UNITED STATES
DEPARTMENT OF THE INTERIOR
BUREAU OF LAND MANAGEMENTFORM APPROVED
OMB NO. 1004-0137
Expires: January 31, 2018**SUNDRY NOTICES AND REPORTS ON WELLS**
*Do not use this form for proposals to drill or to re-enter an abandoned well. Use form 3160-3 (APD) for such proposals.***HOBBS OCD**
CD Hobbs
MAR 19 2018
RECEIVED**SUBMIT IN TRIPLICATE - Other instructions on page 2**

EM Elliott Federal 20 #4

Work Objective: Recomplete Drinkard

Permanent Abandonment of Production Zone Conditions of Approval

CURRENT

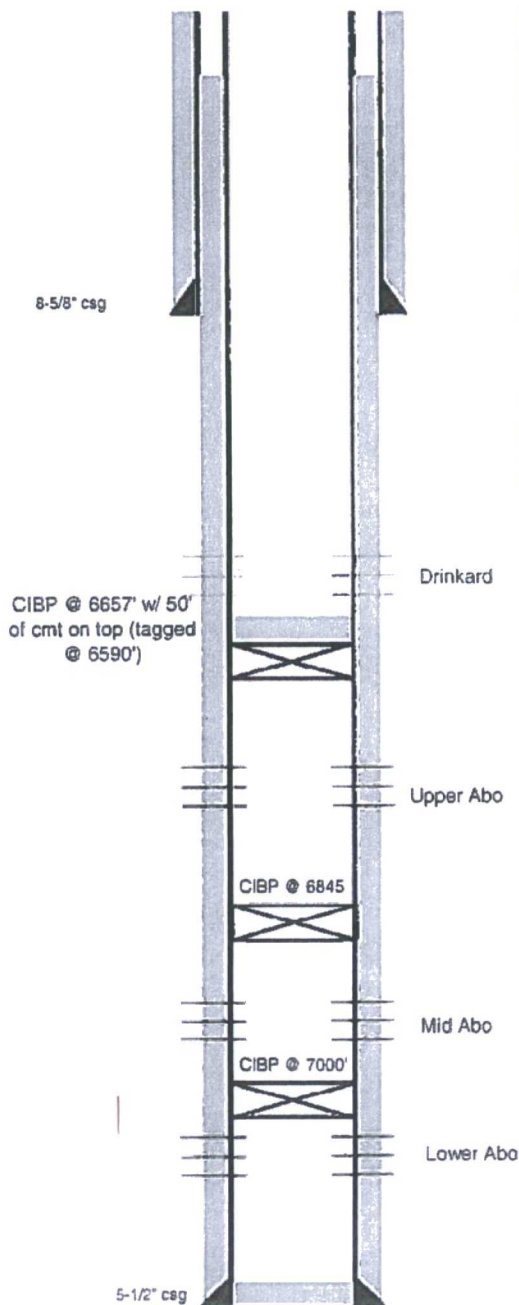
CIBP @ 6657' w/50'
of cmt on top (tagged
6590')

Our recompletion prognosis shows we set the CIBP and cement a bit high—in order to complete the entire Drinkard interval, we will have to deal with the cement on the CIBP.

- First preference is to dress the cement on the bridge plug, and drill out to approximately 6637 ft. This will leave 20 ft of good cement on the CIBP. Drilling out the cement places the well at some risk but we are willing to accept this risk. The Abo perms, while covered with the CIBP and 20 ft of cement, will not be sufficient per Onshore Order 2, but will be sufficient to isolate the depleted Abo. Per the attached well log, the Abo productive zone will effectively be plugged off. This option would require BLM to authorize the plugback with CIBP + 20 ft for this well.

We can go with your first preference to allow you to perforate where needed. When the well is plugged back or abandoned we will require additional cement on the CIBP to provide additional isolation for the Abo.

**Approved for only 20 ft on cement on CIBP at 6657' in order to perforate the productive zones in the Drinkard formation. At final abandonment or when the well is plugged back, a minimum of 25 sx of cement must be pumped on top the existing CIBP to bring the cement to at least 6507'.
